Product Change Notification

Product Change Notification: PCN-26-276844

DEUTSCH Size 16 Pin/Socket and Size 20 Socket New Capacity Tools

Tooling ID Location (Size 16)

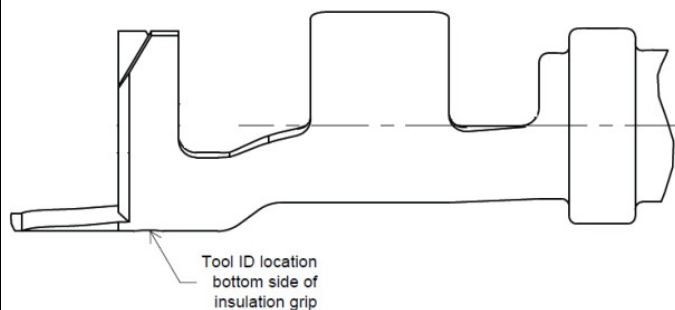
The Industrial and Commercial Transportation business unit of TE Connectivity is adding new capacity tooling for the pin and socket and will be located in China for the part number(s) listed below. These PNs are TE proprietary designs, therefore considered catalog/general market product. PPAP and/or sample requests must be submitted within 14 days (or per contract with TE) of PCN submission via ict-ppap-request@te.com or ePPAP system. Submission will not occur without request. Product drawing(s) are not affected. Size 16 Pin will be identified by tool ID 10 (plating codes 22,44). Size 16 Socket will be identified tool ID 11 (plating code 44) and 12 (plating code 22). Size 20 socket with be identified by tool ID 6 (plating code 44).

Pin Tool ID = 10 (Plating Code 22, 44)
Soc Tool ID = 11 (Plating Code 44)
Soc Tool ID = 12 (Plating Code 22)

Tooling ID Location (Size 20)

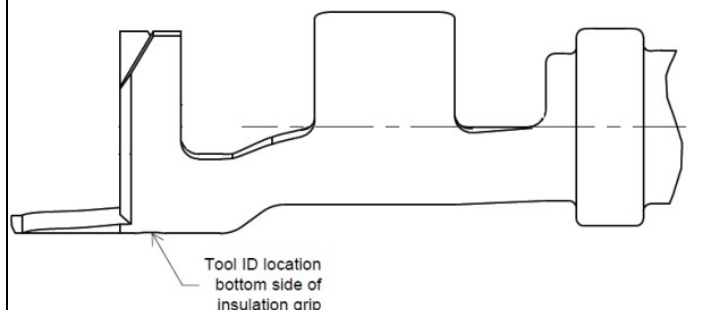
Soc Tool ID = 6 (Plating Code 44)
